# Access Compliance Report

## Public Rights-of-Way

Intersection ID: 9248	Main Street: KALYNNE_ST	Cross Street: RAMONA_ST	Location:	N
ADA ID: C2D79F480032	Ramp Type: Perp	Initial Pass/Fail: Fail	Overall Compliance: No	Severity Score: 21.25
Codes/Mitigation Info/Possible Solution		Field Measurements/Component Compliance

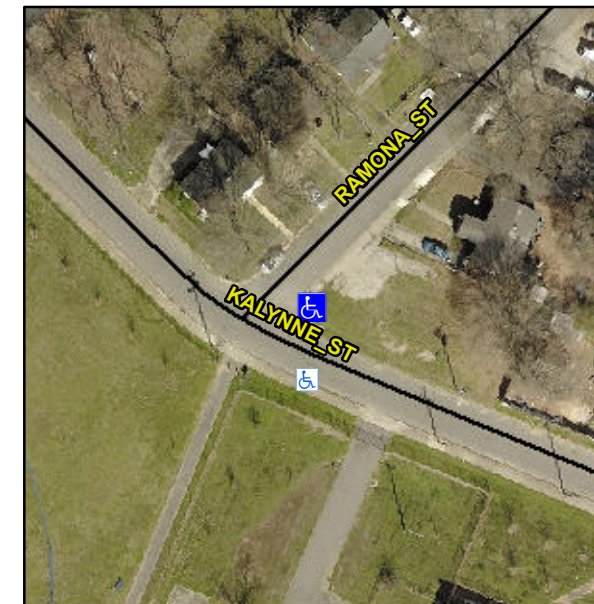
**Not Found, R304.5.1, R304.2.2**

Compliance	Description	Data	Compliance	Description	Data
N/A	Ramp Length (in)	60.0	No	Ramp Slope (%)	11.2
No	Ramp Width (in)	44.0	Yes	Ramp XSlope (%)	1.0
N/A	Flare Type LT	N/A	N/A	Flare Type RT	N/A
N/A	Flare Slope LT (%)	N/A	N/A	Flare Slope RT (%)	N/A
N/A	Flare Traversable LT?	N/A	N/A	Flare Traversable RT?	N/A
N/A	Landing Length (in)	N/A	N/A	DWS Provided?	N/A
N/A	Landing Width (in)	N/A	N/A	DWS Contrast?	N/A
N/A	Landing Slope (%)	N/A	N/A	DWS Length (in)	N/A
N/A	Landing X Slope (%)	N/A	N/A	DWS Full Width?	N/A
N/A	Landing Curb? (Y/N)	N/A	N/A	DWS Offset (in)	N/A
N/A	Shared Landing?	N/A			
N/A	Gutter Ponding?	N/A	N/A	Gutter Slope (%)	N/A
N/A	Gutter Lip Ht (in)	N/A	N/A	Gutter X Slope (%)	N/A
N/A	Painted X Walk1?	No	N/A	Painted X Walk2?	N/A
	X Walk 1 Direction	To S		X Walk 2 Direction	N/A
N/A	X Walk 1 Width (in)	N/A	N/A	X Walk 2 Width (in)	N/A
	X Walk 1 Slope (%)	1.3		X Walk 2 Slope (%)	N/A
	X Walk 1 X Slope (%)	0.5		X Walk 2 X Slope (%)	N/A

**Remove & Replace Entire Ramp.**
